ADDENDUM # 4

**RFQ #7449366 TITLED: New Water Meter Station at the Lincoln
Campus - CCRI**

ADDENDUM NO. 4**New Water Meters**

The following changes, additions, and deletions to the Drawings and Specifications shall be considered part of the Contract Documents called **New Water Meters Community College of Rhode Island Flanagan Campus Lincoln, RI**, dated September, 2011. This Addendum consists of five (5) pages:

SHEET 3 OF 4

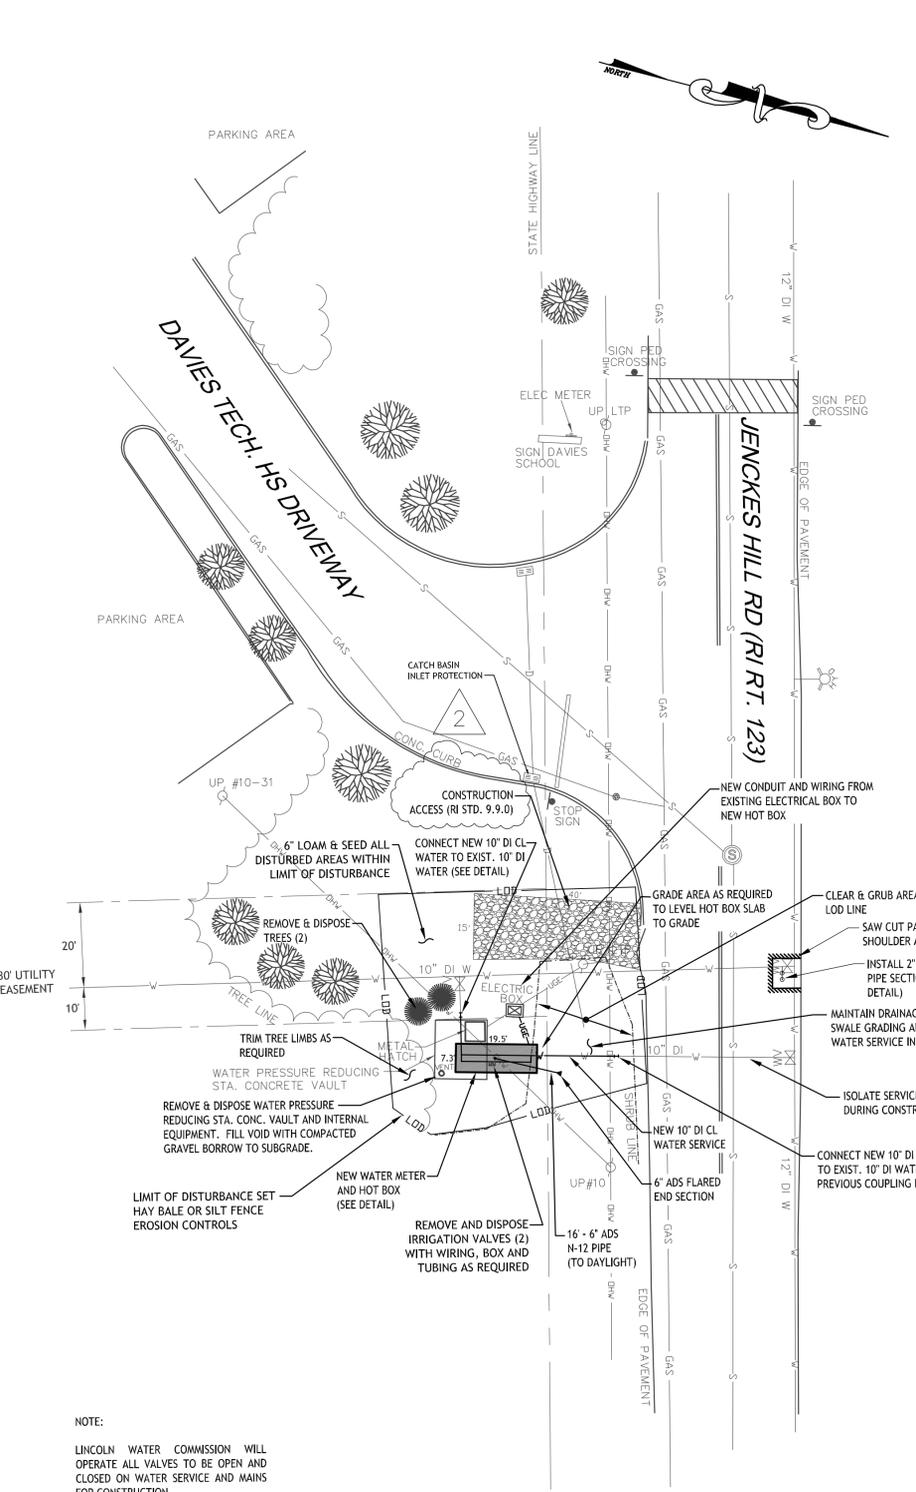
ITEM NO. 9 – Remove existing Sheet 3 of 4 and replace with new Sheet 3 of 4 with Revision No. 2, 2-28-12, Addendum No. 3 in revision box. Revisions have been made to this sheet as follows:

1. A construction access (RI STD. 9.9.0) is now shown in a suggested location.
2. The existing domestic water service outside the building has been identified on the record drawings as a 6" water service. The connection detail to this line has been revised.

CONSTRUCTION ACCESS
N.T.S. R.I. STANDARD 9.9.0

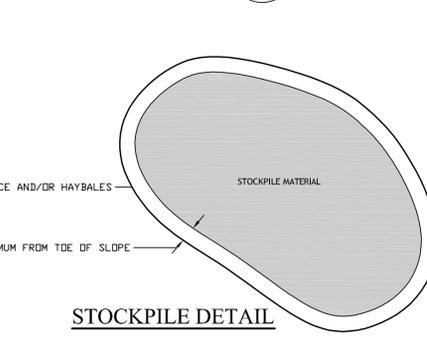
ITEM NO. 1 – *Question:* Construction access road shown on 4 of 4 shows 50' minimum and going to public road (Rt 123) but it is only about 25' to Rt 123. Should this be to Davies tech driveway or length adjusted?

Answer: The access to the new meter hot box site is via the 30' Utility Easement that abuts the Rt 123 right-of-way. The length of the construction access is based on the existing site conditions encountered and not the length shown on the RIDOT Standard Detail 9.9.0. A suggested location is now shown on sheet 3 of 4.

NYLOPLAST INLINE DRAIN
N.T.S.

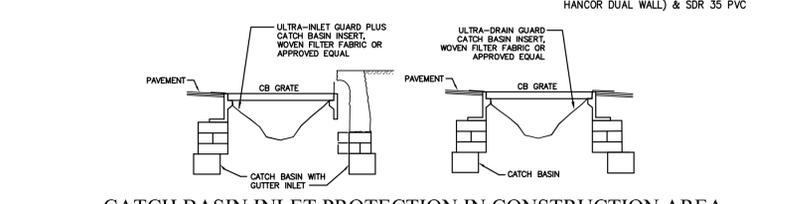
ITEM NO. 2 – *Question:* New detail for the in line drain under the hot box has the line just going past slab. With the water table in this area should this piping have a backwater valve on it, and should this drop into a crushed stone area (only seems to be under pipe and not at outlet)? If so can you please provide some detail? Is this drain even required in a hot box outside?

Answer: The drain is being installed at the request of the Water Authority. A backflow valve will not be required for this installation. A flared end section on the end of the pipe will be sufficient for this application.

FIELD HOUSE WATER METER REPLACEMENT DETAIL
NOT TO SCALE

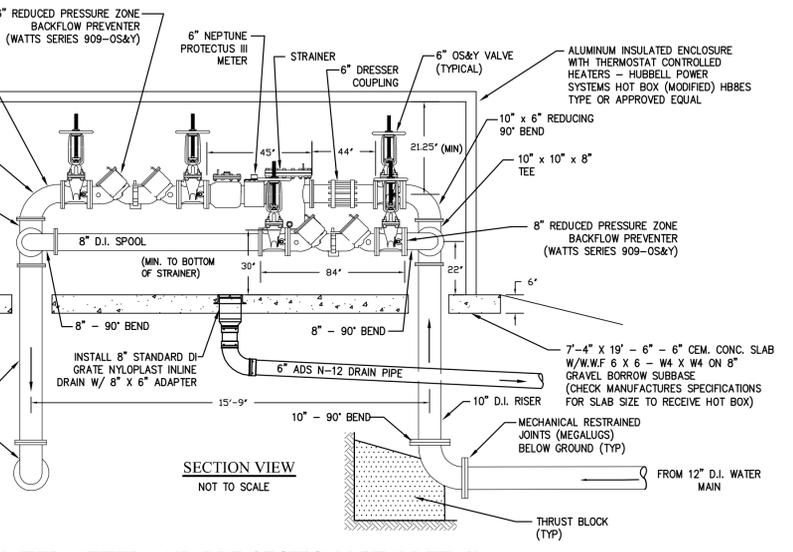
ITEM NO. 8 – *Question:* Is the piping in the field house mechanical room to be re insulated?

1. Added new RPZ relief drain to the Main Building Water Meter Replacement Detail.
2. Revised the New 4" actuated valve from a butterfly valve to a ball valve in the Main Building Water Meter Replacement Detail.
3. Revised New 4" OS&Y on the new drain line to a New 4" OS&Y Ball valve type.
4. Add re-insulate pipes to the Field House Water Meter Replacement Detail.

Answer: Yes. The specification for that insulation is as follows:

MAIN BUILDING WATER METER REPLACEMENT DETAIL
NOT TO SCALE

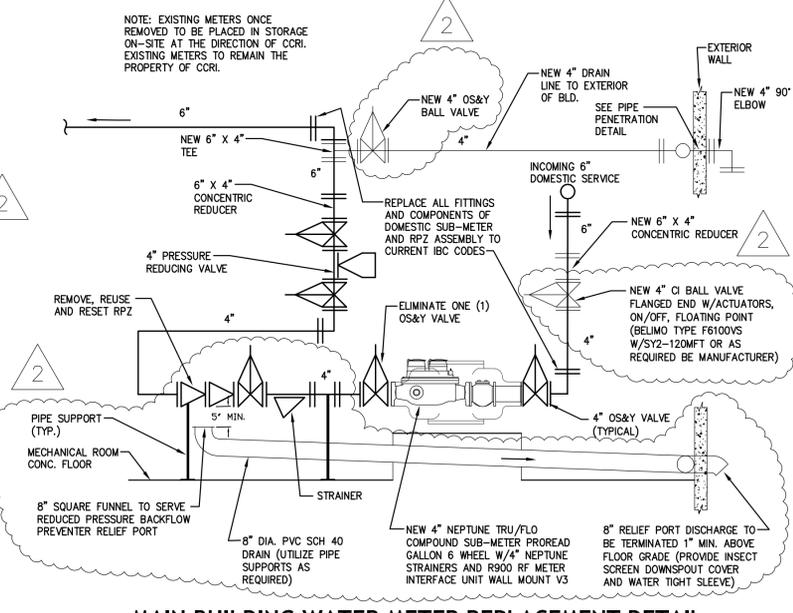
ITEM NO. 6 – *Question:* There is no floor Drain under the RPBF in the main building. Is this acceptable?

Answer: A relief port drain for the RPZ has now been proposed for that area, see sheet 4 of 4.
